# SERVICE BULLETIN

## NO. A2764-71-1

POWER PLANT - FAN COWLING - HOLD OPEN ROD  
REPLACEMENT OF ROD END BEARING

FIGURE 1 - A2764-3 STRUT ASSEMBLY  
EXPLODED VIEW

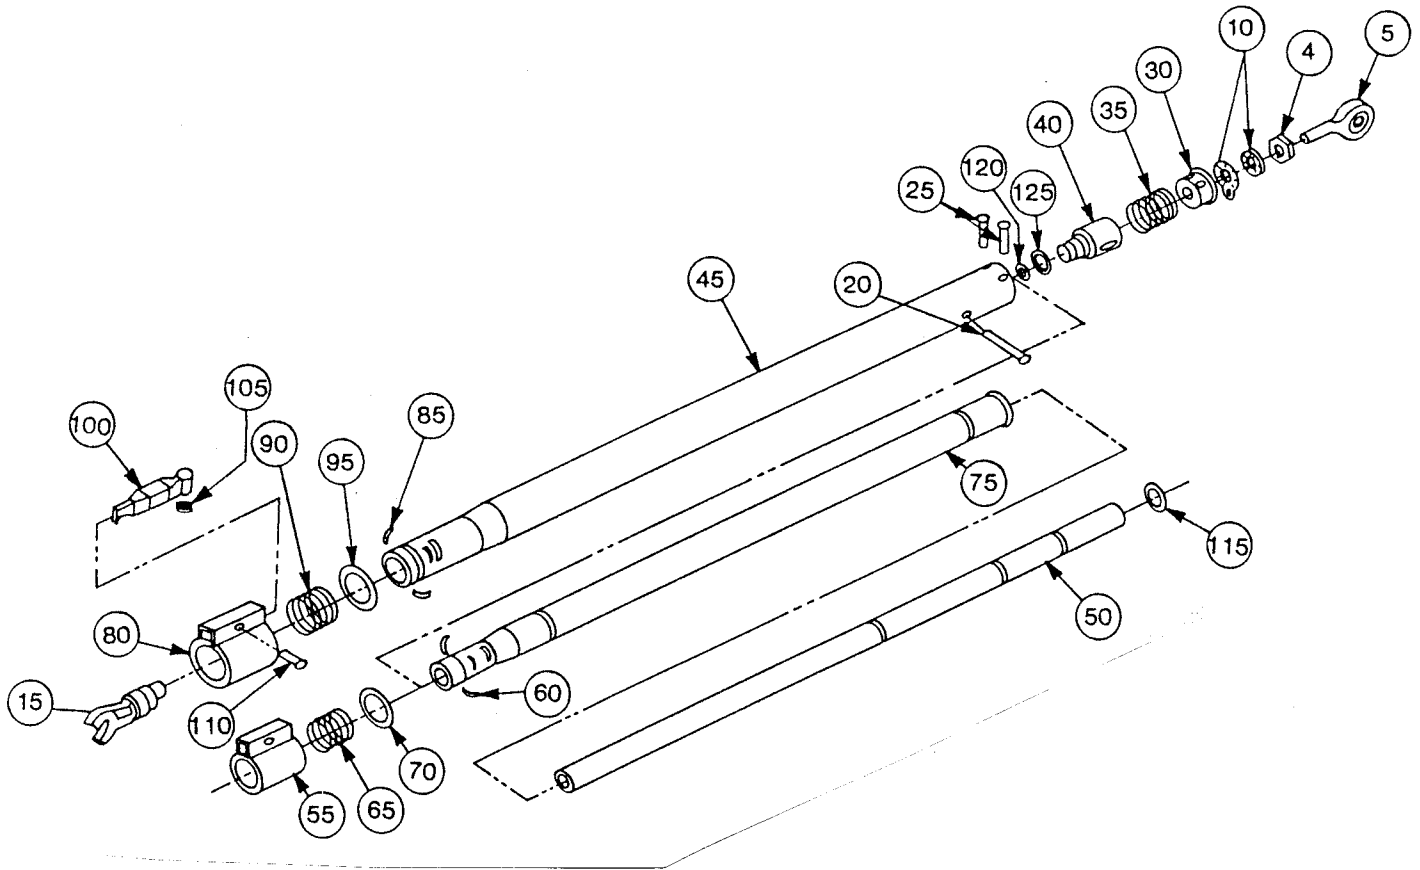
The incorporation of this Service Bulletin will replace the rod end bearing with a stronger one having a larger diameter bolt shank and make this hold open rod equivalent to the new S314T220-16 rod.

This Service Bulletin is to inform all users of the procedures and the detailed instructions required for reworking Norco strut assembly A2764-3 to make it equivalent to S314T220-16. The rework requires replacing the rod end bearing and outer tube.

- (1) Loosen nut (4) on rod end bearing (5) by rotating counterclockwise.
- (2) Remove rod end bearing (5) by rotating counterclockwise. Locking device (10) will come off with rod end bearing (5).
- (3) Remove couplex lock assembly (15) by unthreading in a counterclockwise direction from the inner tube (50). Apply heat (350°F) to loosen thread adhesive.

- (4) Using a 5/32 inch (4 mm) diameter drill, remove rivet (20) by drilling off head and driving out remainder of rivet.
- (5) Using a 3/16 inch (4.75 mm) diameter drill, remove rivet (25) 2 places by drilling off head and driving out remainder of rivet.

- (6) Remove end fitting (30), compression spring (35) and damper (40) from outer tube (45).
- (7) Remove inner tube (50) from assembly by sliding out the back of the outer tube (45) [rod end bearing side]. When inner tube (50) is removed the lock collar assembly (55), locking dogs (60), compression spring (65) and washer (70) will also become free and can be removed from the front of the intermediate tube (75).

- (8) Remove intermediate tube (75) from assembly by sliding out the back of the outer tube (45) [rod end bearing side]. When intermediate tube (75) is removed, the lock collar assembly (80), locking dogs (85), compression spring (90) and washer (95) will also become free and can be removed from the front of the outer tube (45).

<u>Item No.</u>	<u>Parts to Scrap</u>
(45)	Outer Tube
(20)	Rivet
(25)	Rivet (2)
(30)	End Fitting
(4)	Nut
(5)	Rod End Bearing
(10)	Locking Device

- (1) Replace outer tube (45) with new outer tube, part number AM2764-16-2.
- (2) Two dowels or metal rods are required for use as assembly tools. These should be 4.5 inches (114.3 mm) long and the following diameter:

- (5) Screw couplex (15) into end of inner tube (50). Torque couplex (15) to 35 ft. lbs. Stake 4 places 90° apart at a distance of 0.25 inches from the face of the inner tube (50). Staking tool should produce an indentation, 0.060 by 0.20 inches.

- (6) Install damper into outer tube (45) "O" ring end first and align slot in damper (40) with hole in outer tube (45). Place rivet (20) through hole in outer tube (45) and slot in damper (40). Form head on rivet (20), part number MS20470-AD5-24, to retain in place.

- (8) Insert compression spring (35) and end fitting (30) into outer tube (45). Insert the 2 rivets (25), Part number AM1233-9-15, through outer tube and end fitting so that an approximate equal length protrudes on each side of the outer tube. Form heads on rivet using a riveting tool.

- (9) Install lock nut (4), part number AN316C8R, locking device (10), part number 108CO500-01, and lock washer, part number NAS513-8, on rod end bearing (5), part number 26CO313-10. Screw rod end bearing (5) into end fitting (30).

- (10) Set strut to its fully extended and locked position. Using a premeasured appropriately marked rod standard, adjust rod end bearing to obtain overall length of  $72.81 \pm .03$  inches. Length is measured from center of couplex (15) opening to center of rod end bearing (5) bore. Tighten lock nut (40).
